RE: Major Thoroughfare Plan modifications to the future extension of Kunz and Modena School Roads in the Rosenberg ETJ

MTP Proposed Amendment

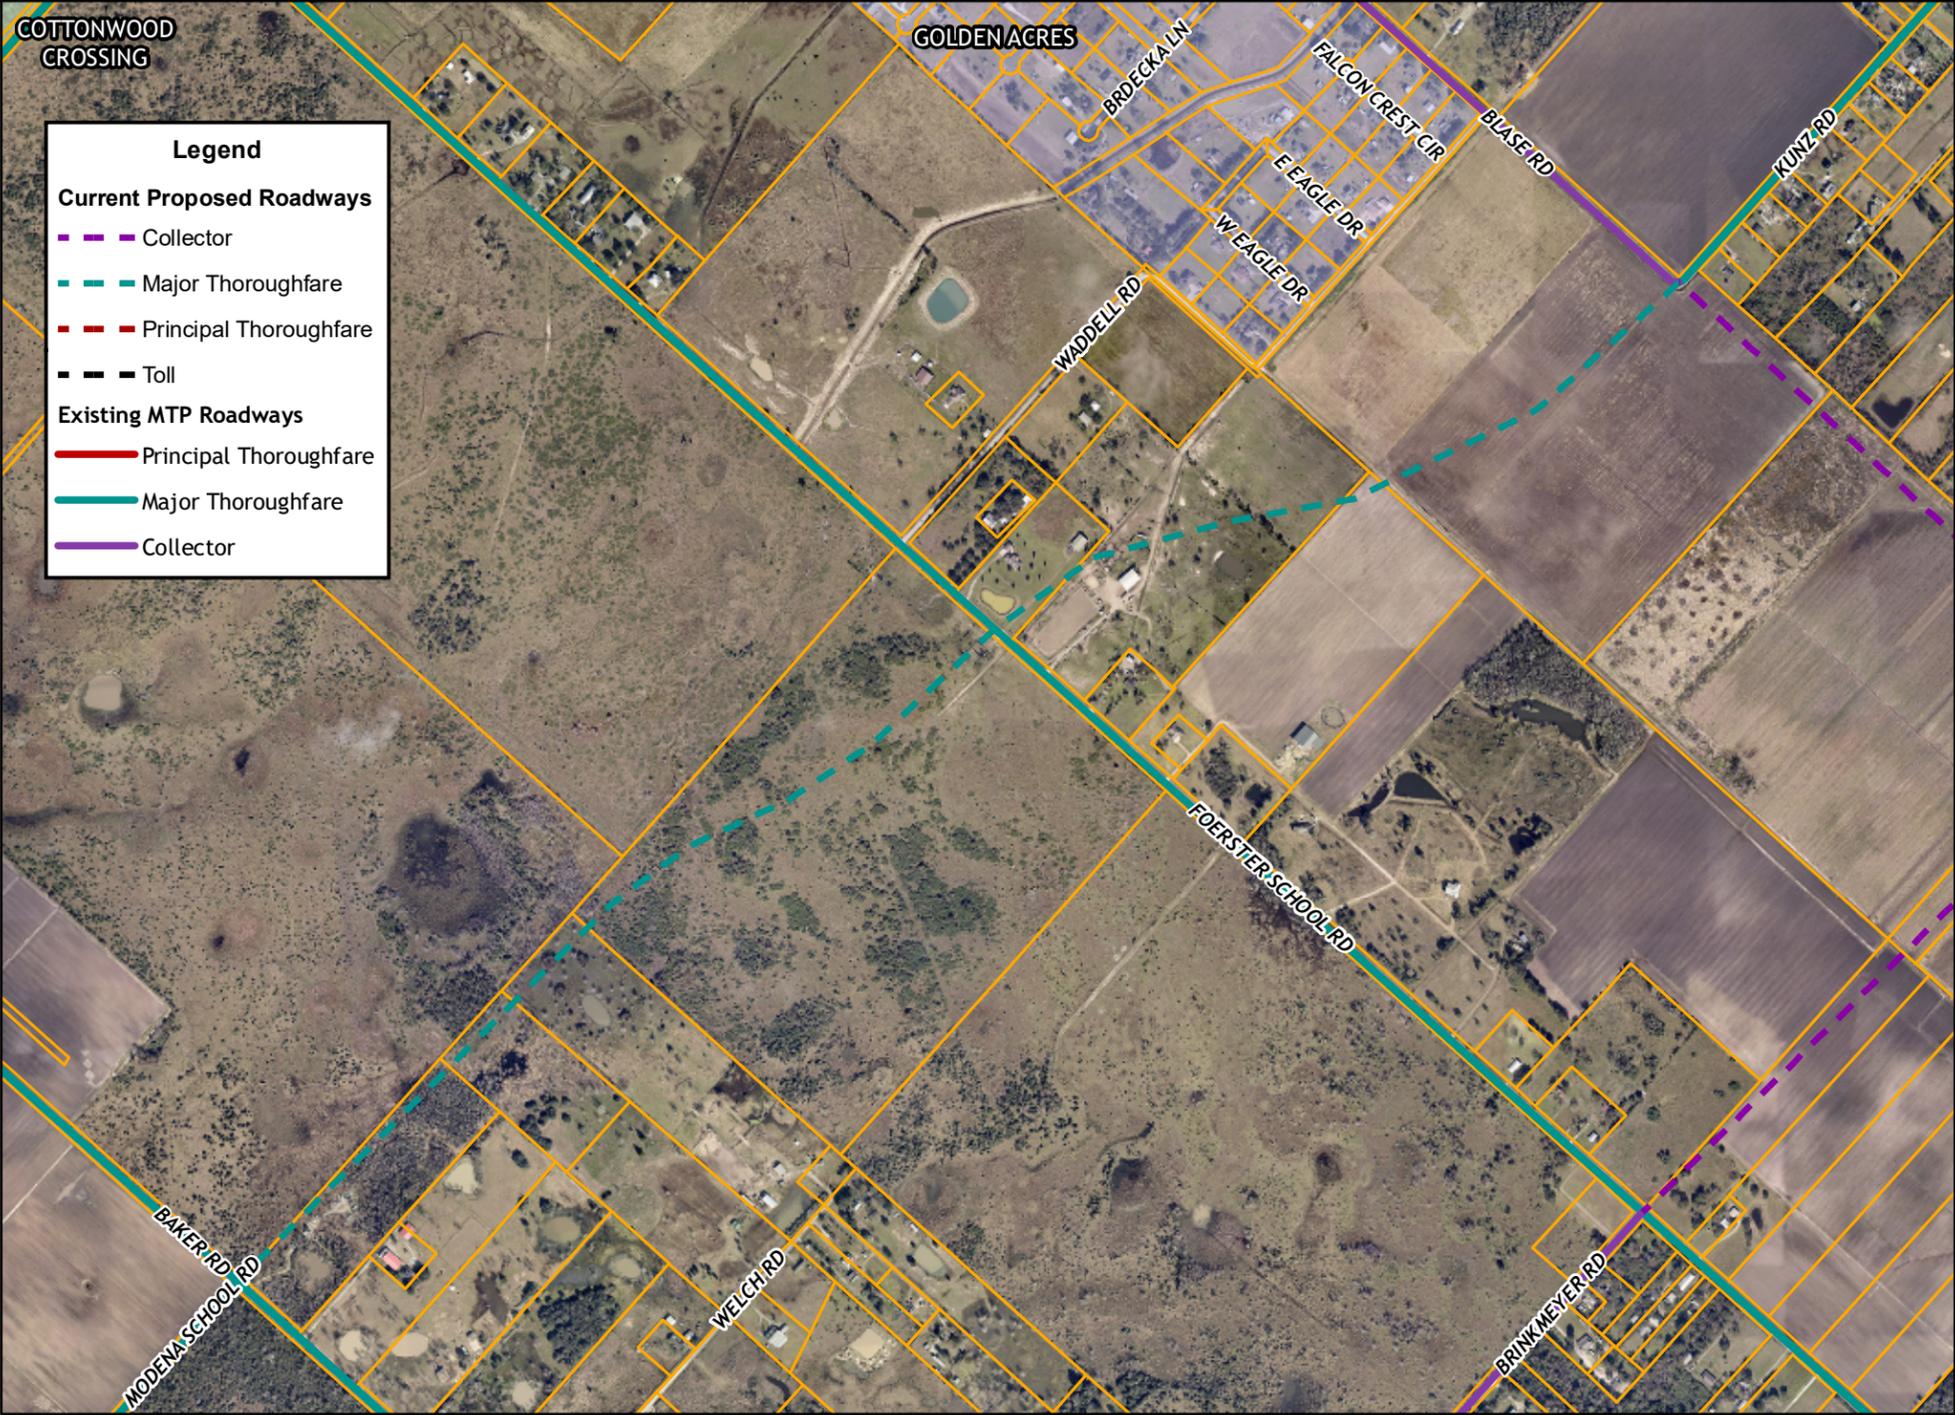
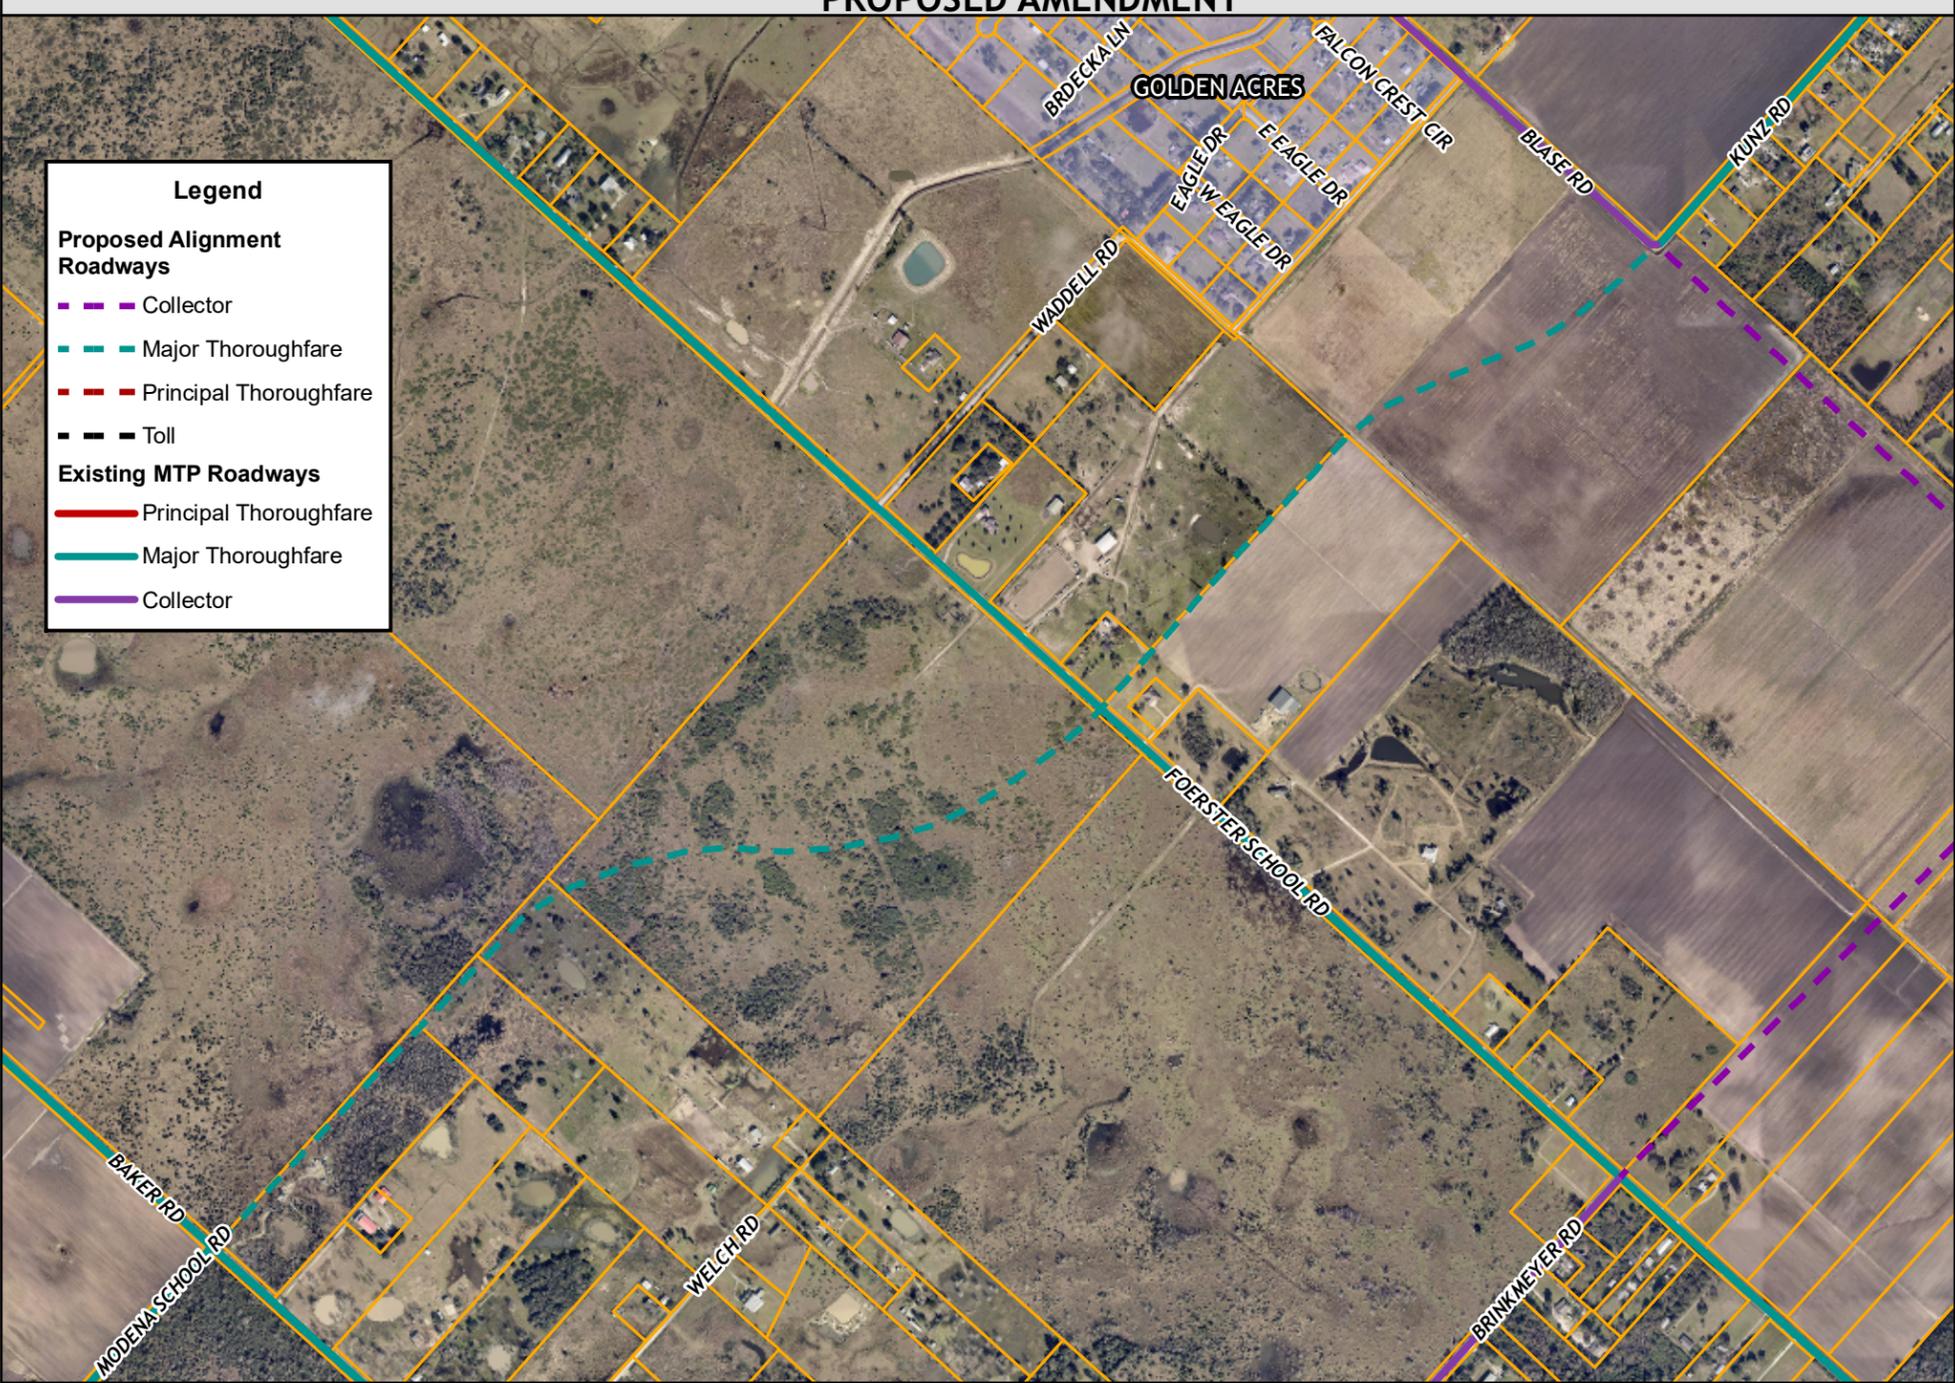
- **Kunz and Modena School Roads alignment**
 - This request is to adjust the alignment of the thoroughfare to align with the edges of properties, rather than bisecting, and adjust the curves to meet the 2,000' centerline requirement for Major Thoroughfares.
